WATER QUALITY MEMORANDUM

Utah Coal Regulatory Program

RE: First Quarter 2017 Water Monitoring, Bowie, Fossil Rock Mine, C/015/0009, Task ID #5474

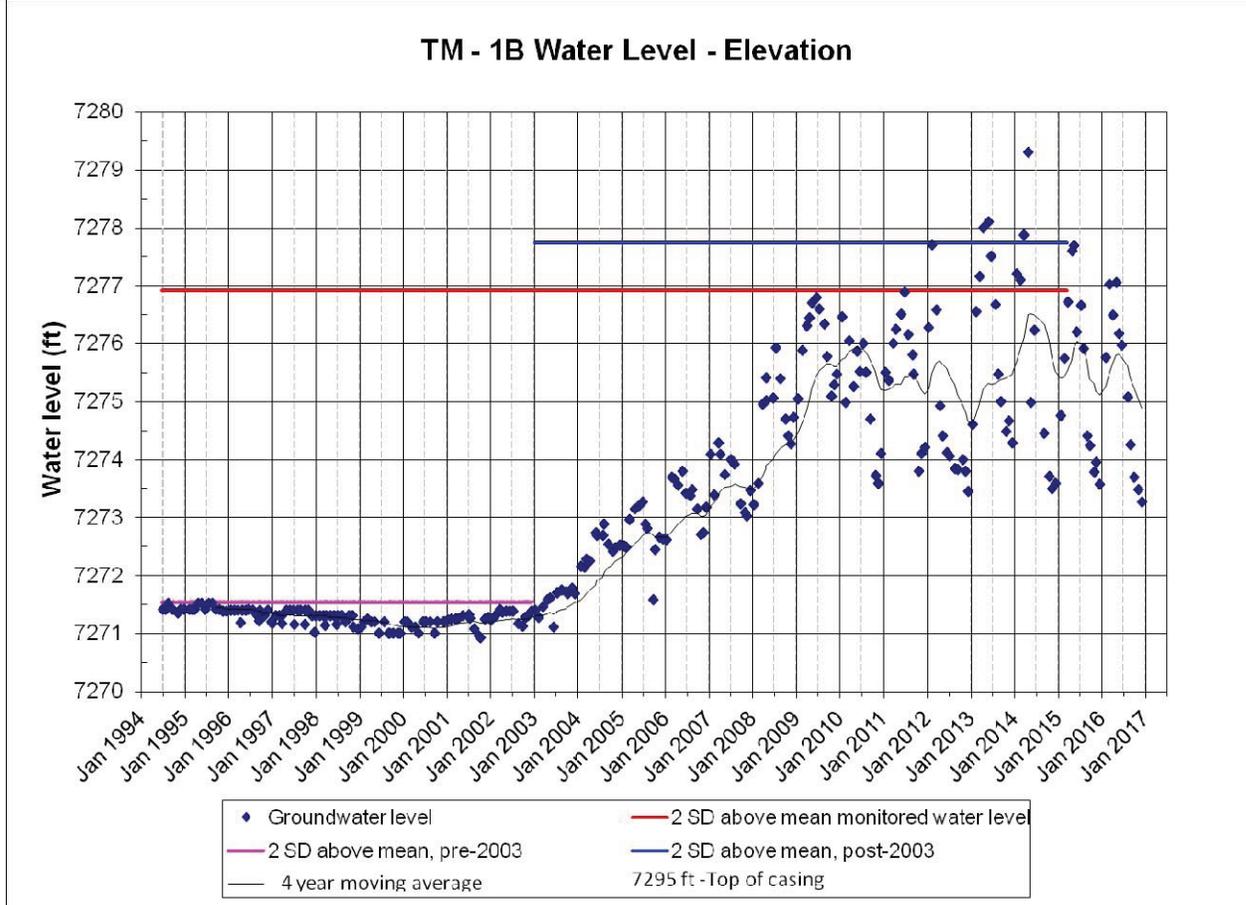
Well TM-1B is monitored for water level monthly and for operational parameters quarterly (Figure 1). Since July 2004, the water level in TM-3 has been reported as potentiometric head above the well casing by measuring the pressure on top of the sealed wellhead with a gauge (Figure 2). CCCW – 1A, CCCW – 1S, CCCW – 2A, CCCW – 3A, CCCW – 3U, CCCW – 3L are monitored for water level only (Figure

Figure 1. The water level in TM-1B has been rising since mine dewatering ceased in May 2001. It's difficult to say where this value will come to rest. The well is completed in the Panther tongue of the Star Point sandstone below the mine workings. This tongue contacts the floor of the mine workings. Mine dewatering reduced the potentiometric head within the unit and the mine pool is recharging the unit. This graph will be updated when mining begins in the Cottonwood Track.

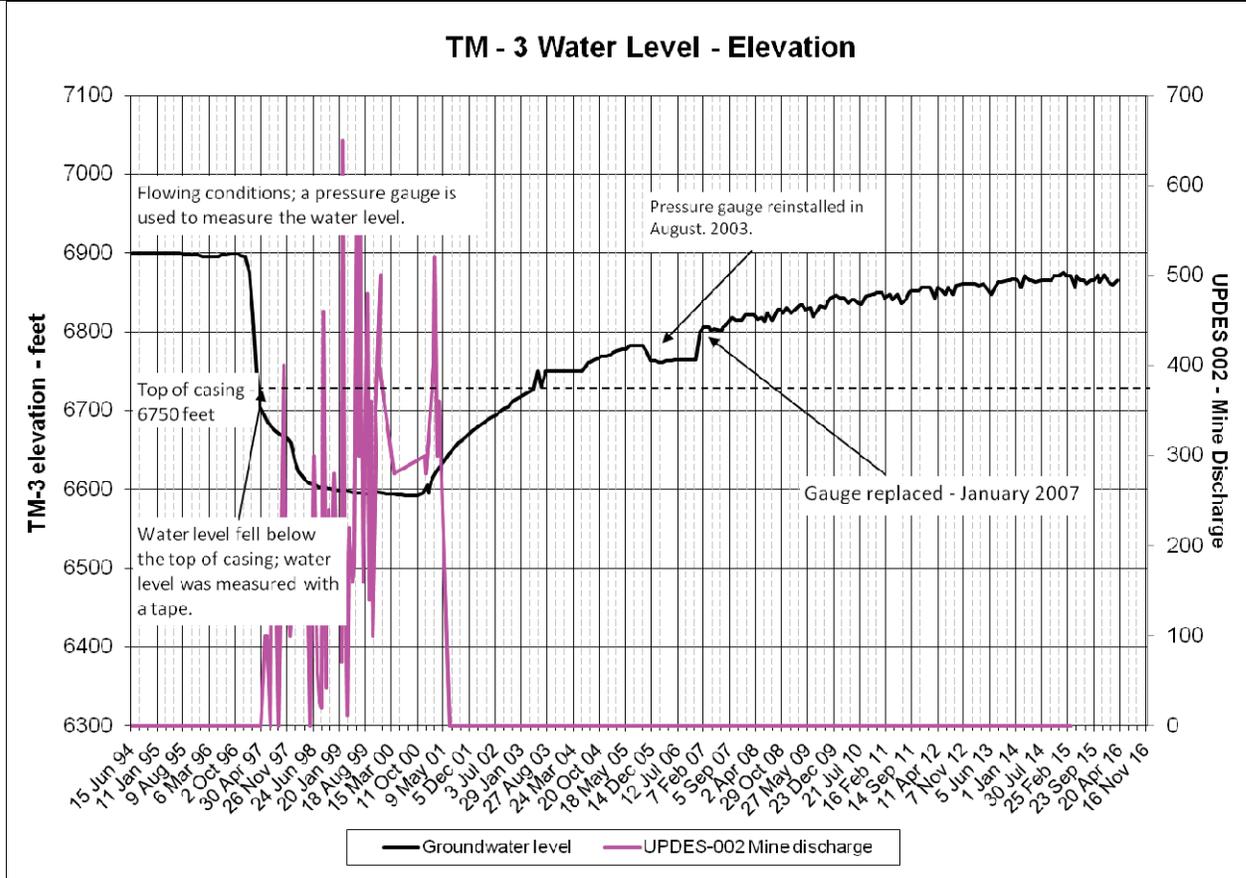
Figure 2. TM-3 water elevation peaked in June 2005, remained steady through October, dropped 18.5 ft in November and December 2005 and remained virtually unchanged during 2006. The pressure gauge was replaced in January 2007 and values jumped to approximately match the pre-2006 curve. During the first half of 2007 the curve was relatively flat, but it has been steadily climbing. The outgoing document Reduce Hydrologic Monitoring Sites, PacifiCorp, Deer Creek, C/015/0018, Task ID #4332 stipulates this well should not be released until 6,900 ft is reached. This graph will be updated when mining begins in the Cottonwood Track.

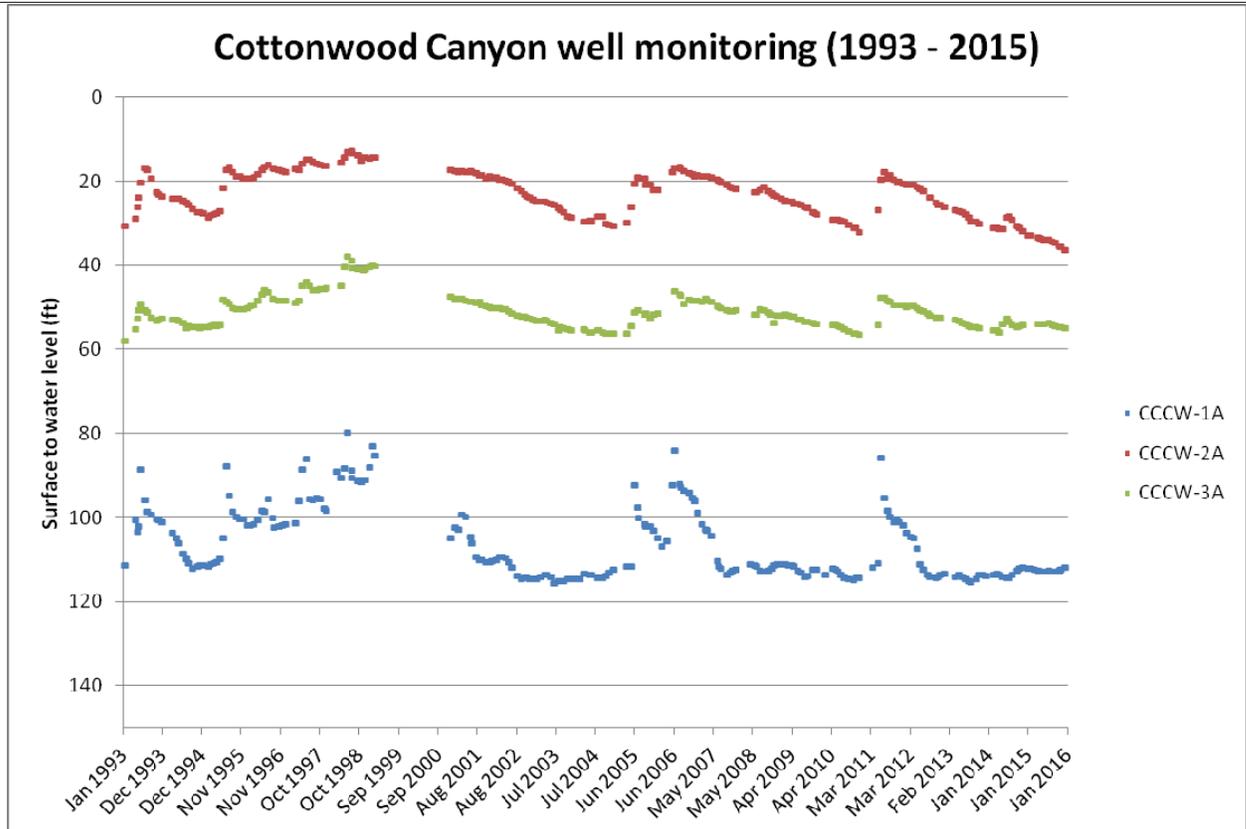
APPX incorrectly subtracted the depth to water measurements from the elevation of the casing to calculate the Water Level values. This means the 'Depth' water level measurement is correct, but WL or water level elevation is incorrect.

Figure 3. Alluvial aquifer water levels in the Cottonwood Canyon Creek monitoring wells. The drill hole data is found in Trail Mountain MRP Appendix C p. 23. This graph will be updated when mining begins in the Cottonwood Track. At this time the wells are primarily responding to climatic variability.

Note: The mine operator needs to submit Depth and WL for all well measurements.
